REFERENCE:	Nova Bus Manuals
SECTION:	16: Electrical system
RS N°:	MQR 7621-2926
EFFECTIVE IN PROD.:	LF70
TC RECALL N°:	2025-176
NHTSA RECALL N°:	25V-213

SUBJECT:	Electrical harnesses and connectors
JUSTIFICATION:	The affected vehicles may have been manufactured with a wire harness assembly of inadequate length. This defect results in excessive tension within the cables, which can lead to wires being pulled out of their connector sockets. Additionally, the compromised assembly may allow water to infiltrate the connectors, exacerbating the issue. Over time, these conditions can cause a loss of critical signals necessary for vehicle operation, potentially leading to a loss of motive power. A loss of motive power may increase the risk of a crash.

Figure 3 - Remove and Replace the WHA 47

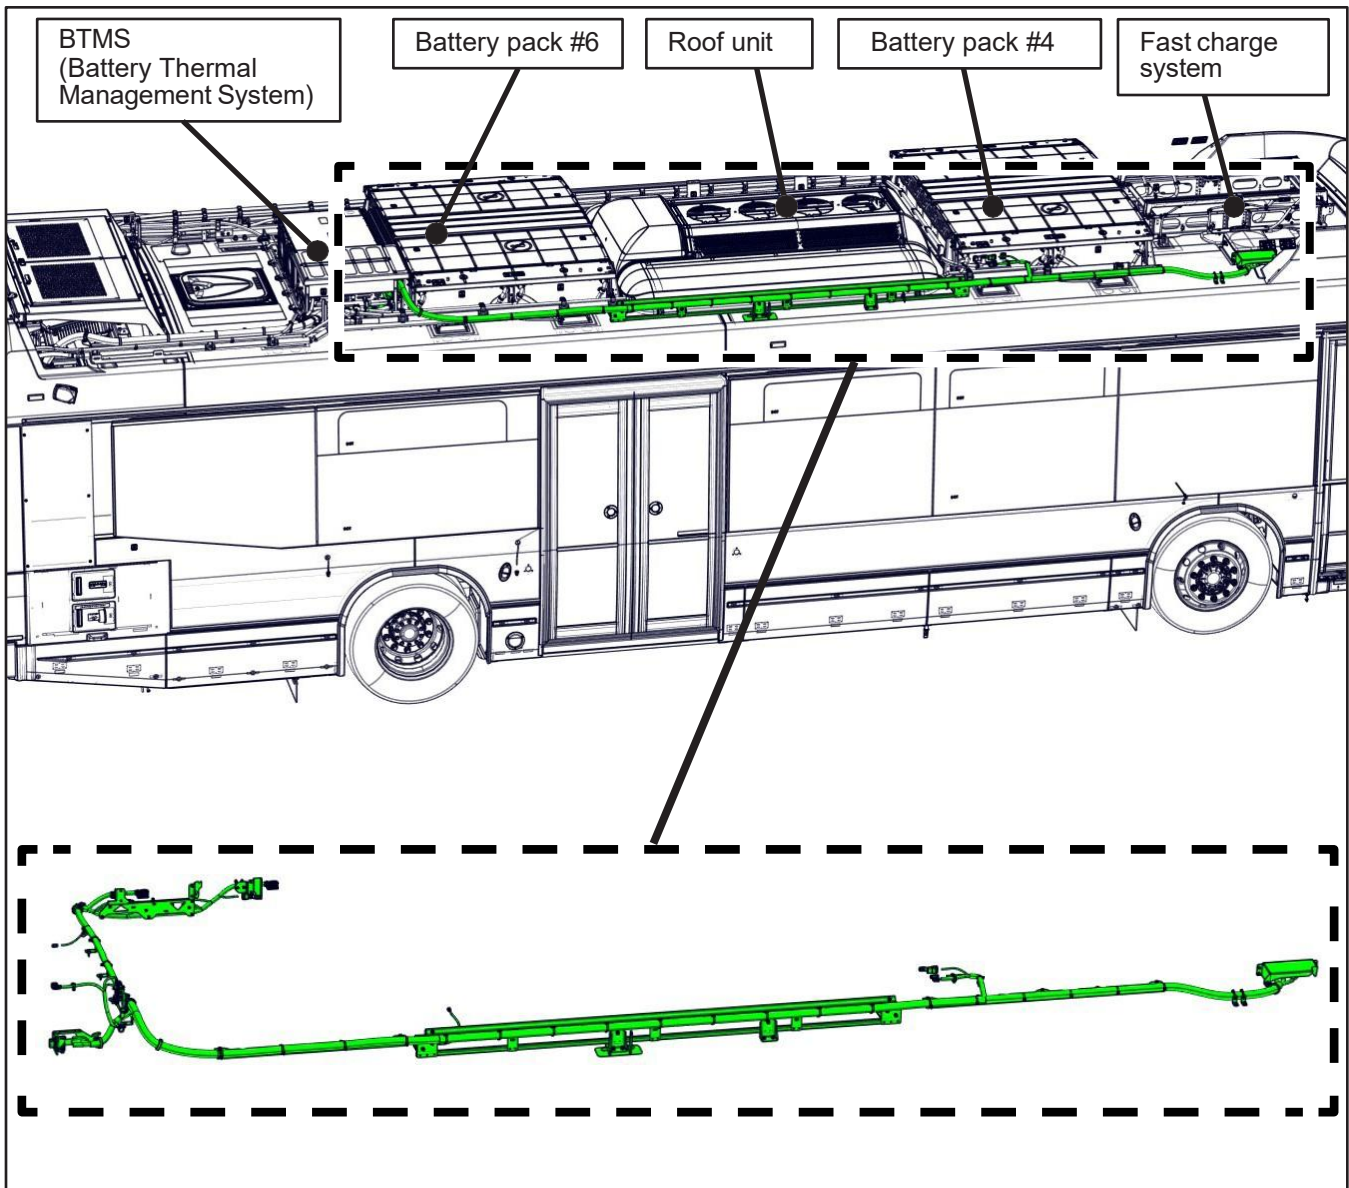
- 1.6. Remove and discard the original WHA 47. To facilitate subsequent installation of the new harness 47, it is recommended to take notes and/or photos when removing the original one in place.

- 1.7. Install the new WHA 47 by aligning the white tapes with the clamps. Secure it exactly as the original was with the retained hardware and new cable ties N68156.

Figure 4 - WHA 47 Routing (Front Right Side)

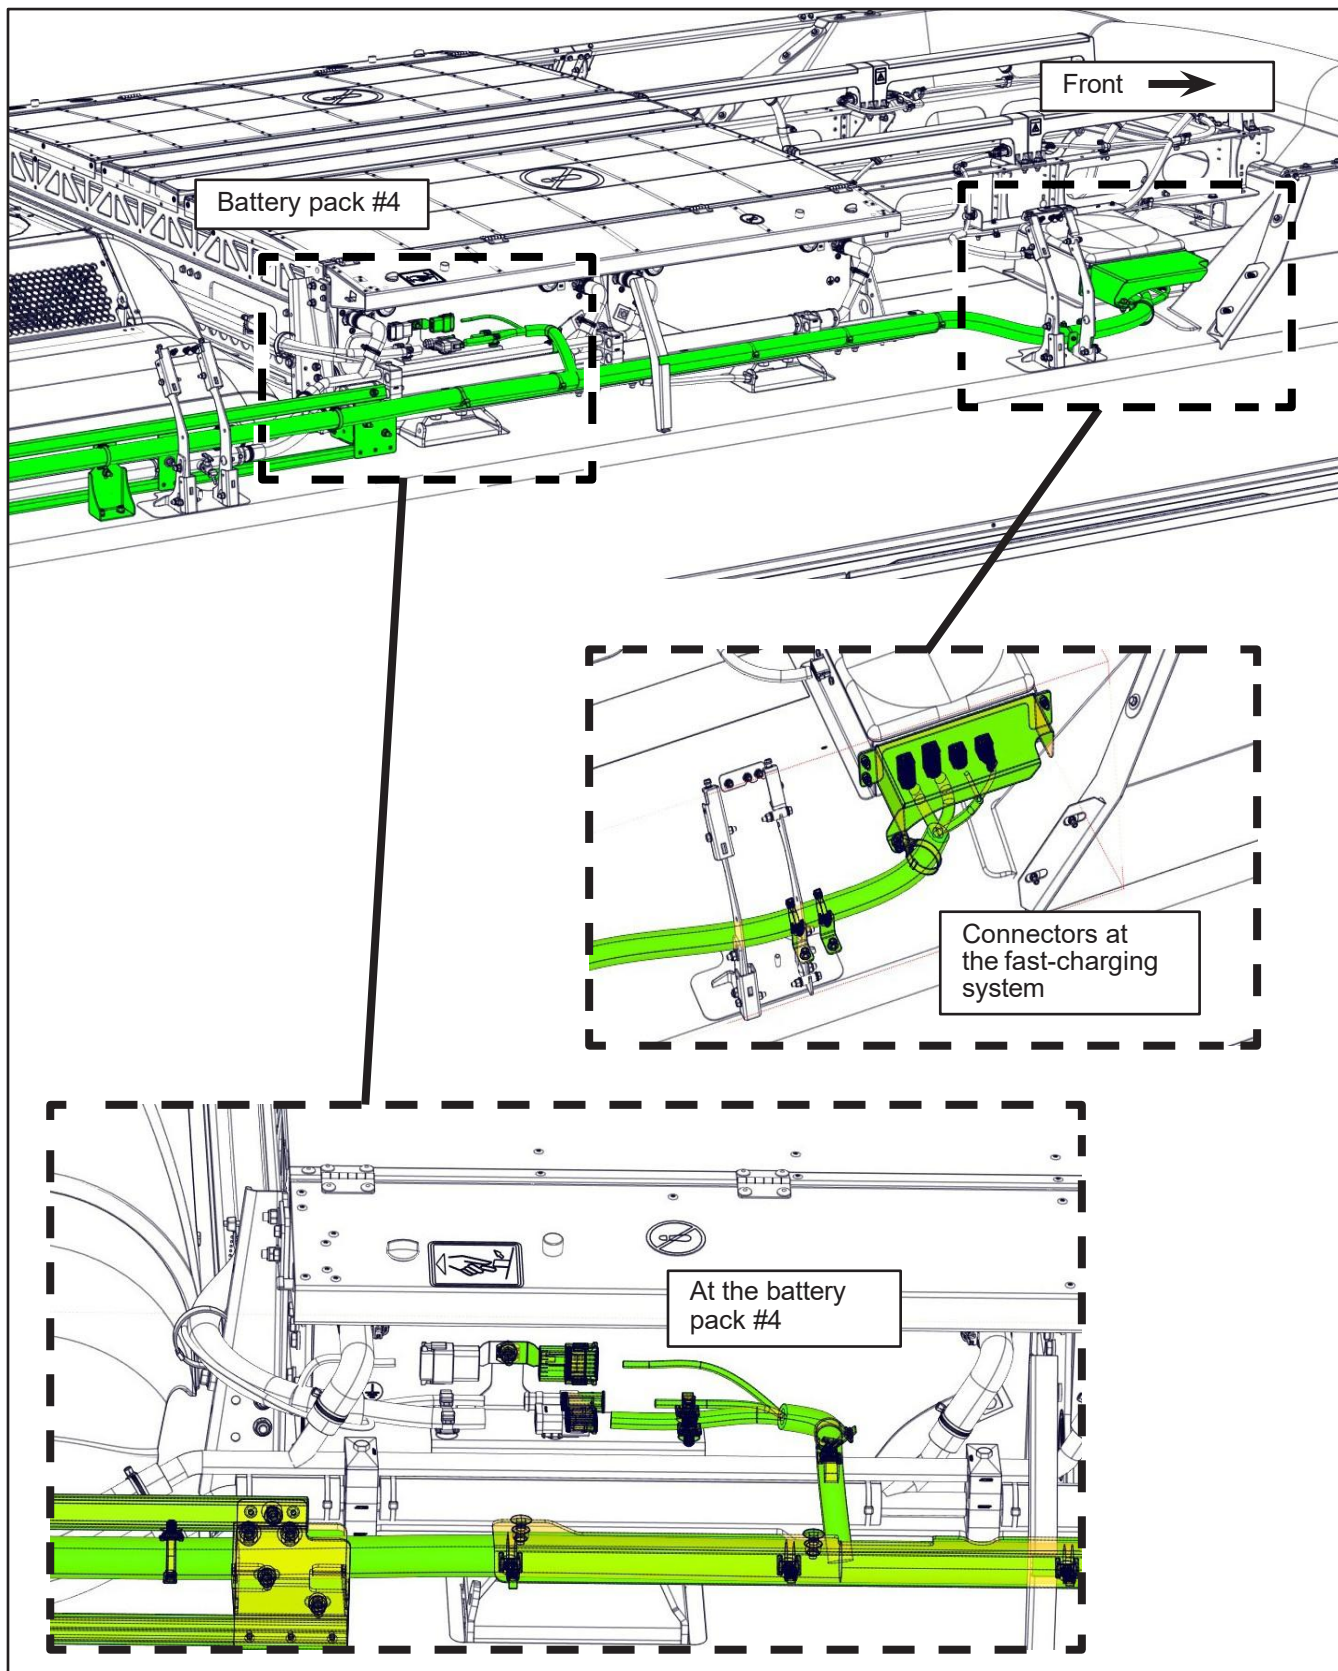
Note: do not connect yet at the fast charge system because it will be required to inspect at the male connectors BR1X4711B, BR1X4711C and BR1X4711D on page 11. Same thing at the BTMS, page 12.

Figure 7 - Inspect the Connectors to the Fast Charging System, View From the Roof

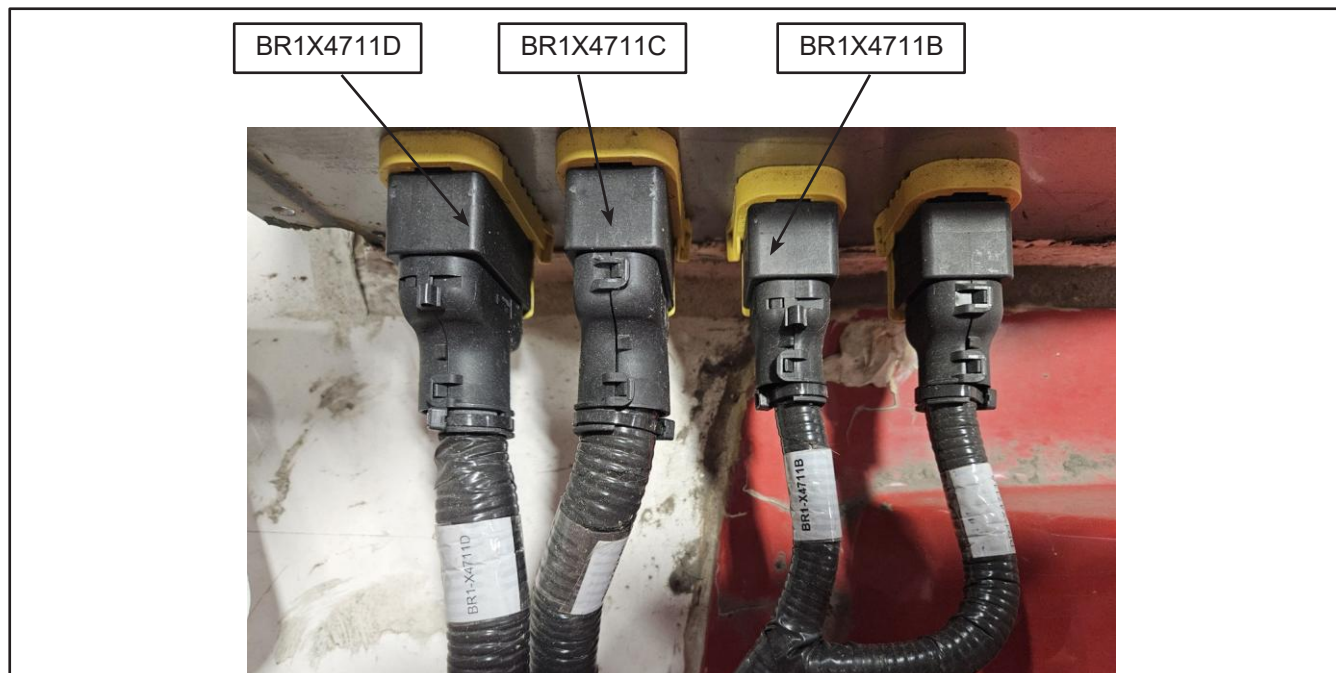
- 1.8. Inspection at the male connectors BR1X4711B, BR1X4711C and BR1X4711D. See the next figure and the Figure 4 "Connectors at the fast charging system". If signs of water ingress, corrosion or damage are found, see level 2. If a yellow mounting clip breaks, see the material list level 2.

Figure 8 - Inspect the Connectors From the Inside of the Vehicle

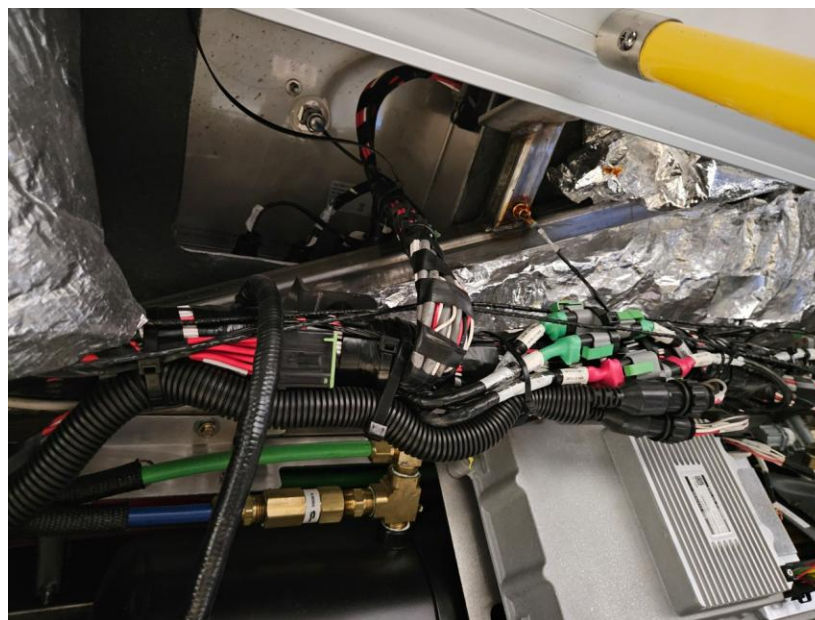
- 1.9. On the same connectors but from the inside of the vehicle, inspect if cavity plugs are missing or damaged. Install the required cavity plugs (already supplied with the Level 1 parts). Insert the cavity plug until it is 1-1.5 mm from the edge of the socket hole. Cavity Plugs N86352-08 for BR1X4711B and BR1X4711D. Use N86352-04 for BR1X4711C.

Figure 9 - Inspect connectors XT5-X6747A and XT5-X6747E

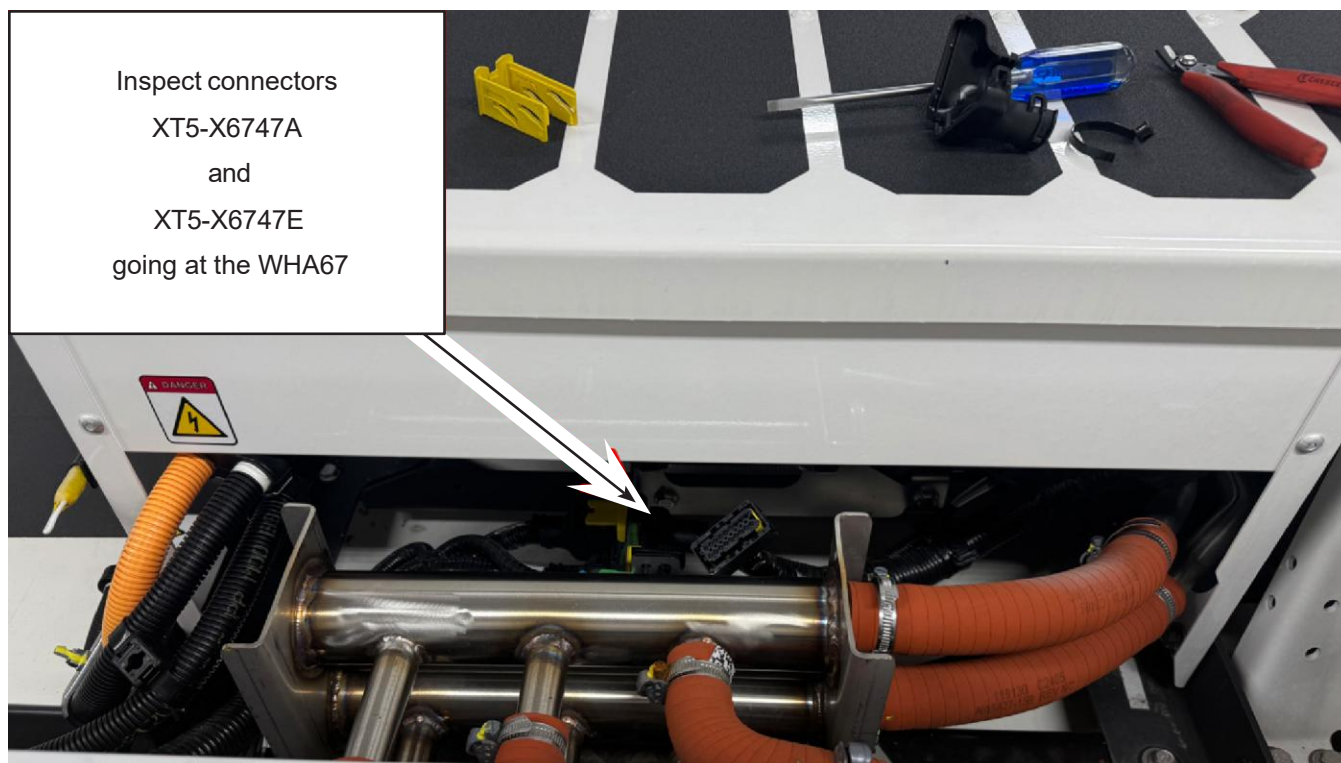
- 1.10. At the BTMS, inspect connectors XT5-X6747A and XT5-X6747E going at the WHA67, see the next figure and the Figure 5 "At WHA 67". Remove the back shell, if seals or damage are found or if signs of water ingress, see level 2.
- 1.11. If no discrepancies were found but cavity plugs are missing, install the required cavity plugs (already supplied with the Level 1 parts). Insert the cavity plug until it is 1-1.5 mm from the edge of the socket hole. Cavity plugs, N86352-08 for XT5-X6747A and XT5-X6747E.

Figure 10 - Example of a Staggered Repair

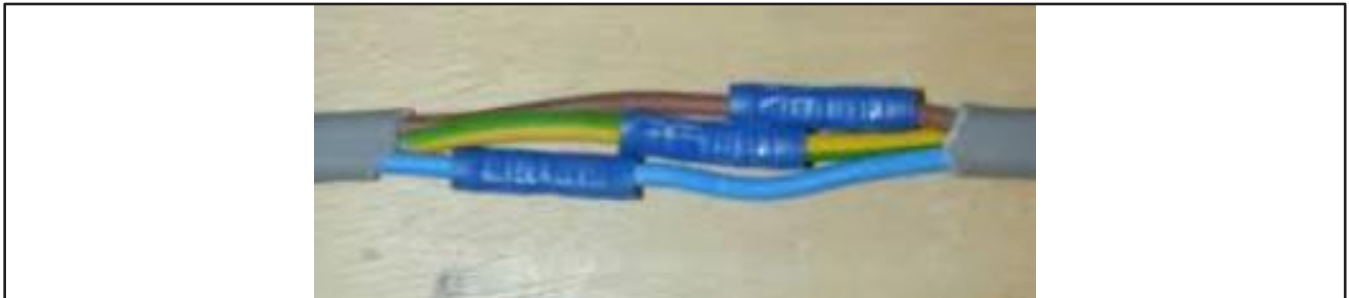
- 2.3. If 1 or more of the connectors inspected were found with a sign of corrosion, water ingress or if a seal is torn or pulled out, use the Level 2 material list accordingly and replace the connector. Discard the original connector.
- 2.4. When installing the wire kit, it is best practice to stagger the splices / wire crimps to provide a safer and reliable electrical work.
- 2.5. If required, install or replace the missing cavity plugs.
